Access Compliance Report Public Rights-of-Way (Pedestrian Signals)

Main Street: **ANTONIO_PKWY** Cross Street: **STATION_WAY** Location: **NE**

ADA ID: **SGRK211116113534** Signal Type: **One Push Button-APS** Overall Compliance: **No** Severity Scores: **BTN 1: 0** **BTN 2: N/A** **No BTN: N/A**

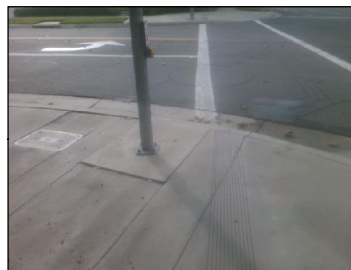
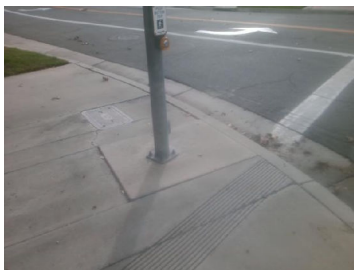
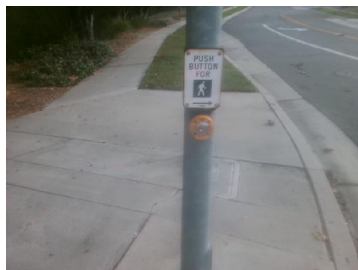
N/A Is Button 1 APS or Non-APS?	APS	N/A Is Button 2 APS or Non-APS?	N/A
N/A B 1 VibroTact Arrow?	No	N/A B 2 VibroTact Arrow?	N/A
Yes B 1 VibroTact Parallel to Xing?	No	N/A B 2 VibroTact Parallel to Xing?	N/A
N/A B 1 VibroTact Contrast	No	N/A B 2 VibroTact Contrast	N/A
Yes B 1 Pilot Light?	Yes	N/A B 2 Pilot Light?	N/A
No B 1 Pilot Light Illumination?	Yes	N/A B 2 Pilot Light Illumination?	N/A
N/A B 1 Walk Indicator Type	PercussiveTone	N/A B 2 Walk Indicator Type	N/A
N/A B 1 Walk Indicator Audible?	Yes	N/A B 2 Walk Indicator Audible?	N/A
N/A B 1 Locator Tone?	Yes	N/A B 2 Locator Tone?	N/A
N/A B 1 Tone Audible Range?	Yes	N/A B 2 Tone Audible Range?	N/A
B 1 Addl APS Features?	No	B 2 Addl APS Features?	N/A
B 1 Addl APS Features Notes	N/A	B 2 Addl APS Features Notes	N/A

Possible Solutions: Align Push Button With Crosswalk.
